N3383A-01C

S E R V I C E N O T E

Supersedes:
N3383A-01B

N3383A PNA Series RF Network Analyzers

Figure 1

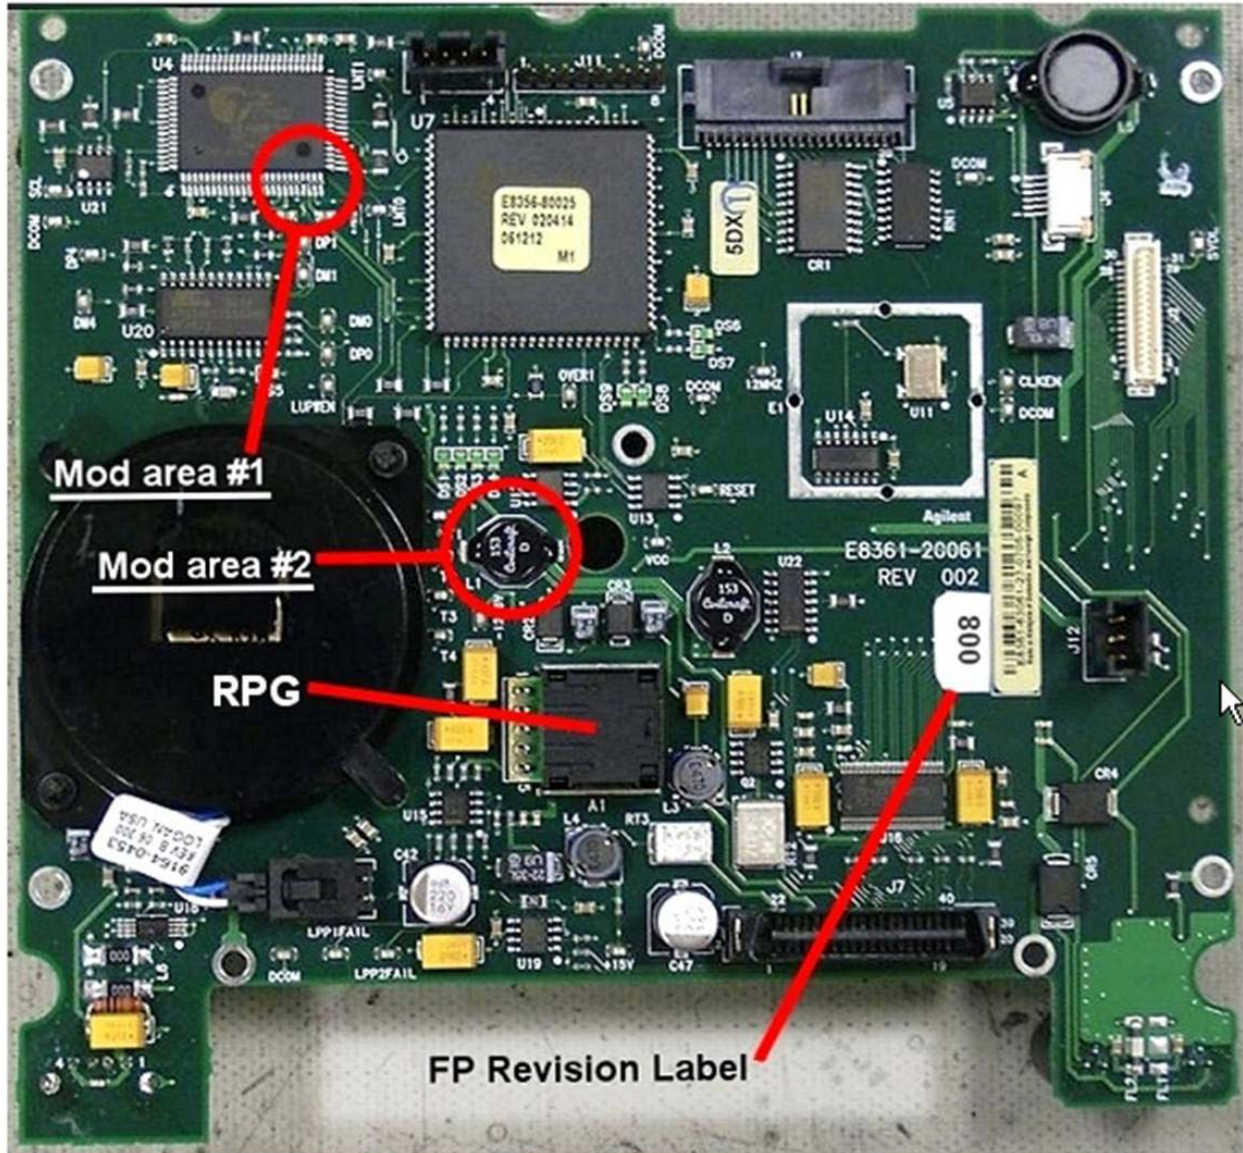
Refer to Figure 1 for the two modification areas to be addressed. Note that while this picture happens to show the FPI board completely removed from the front frame assembly, this is not necessary to perform the required modifications.

- Modification #1 consists of shorting two pins of U4 together with a small amount of solder.
- Modification #2 consist of removing L1.

Figure 2

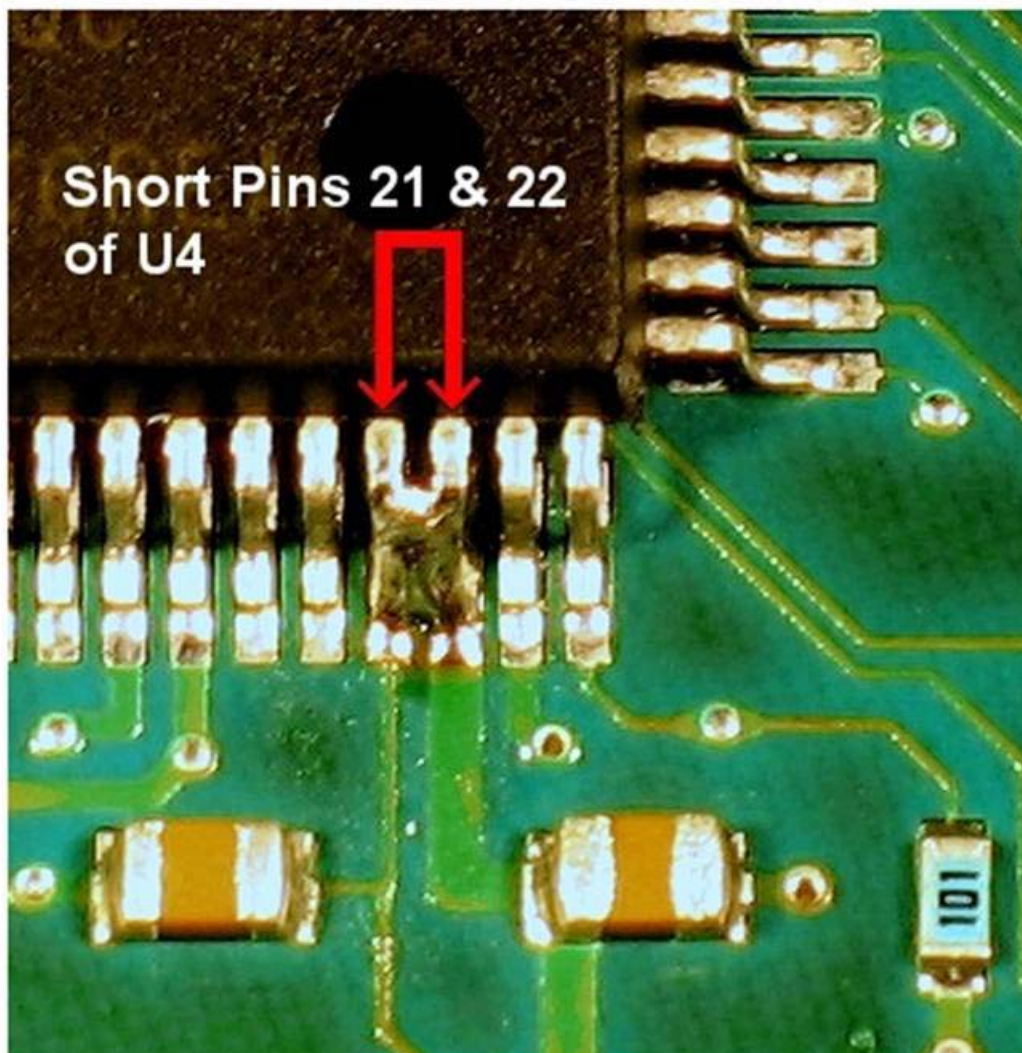
Carefully solder pins 21 and 22 together on U4. Refer to Figure 2 for the exact location. Use care so that no other pins are shorted. Use of a very fine tip soldering iron is recommended and a large work-task magnifying glass is very helpful.

Unsolder and completely remove the black surface mount inductor L1 from the front panel assembly board. This is no longer needed and can be discarded.
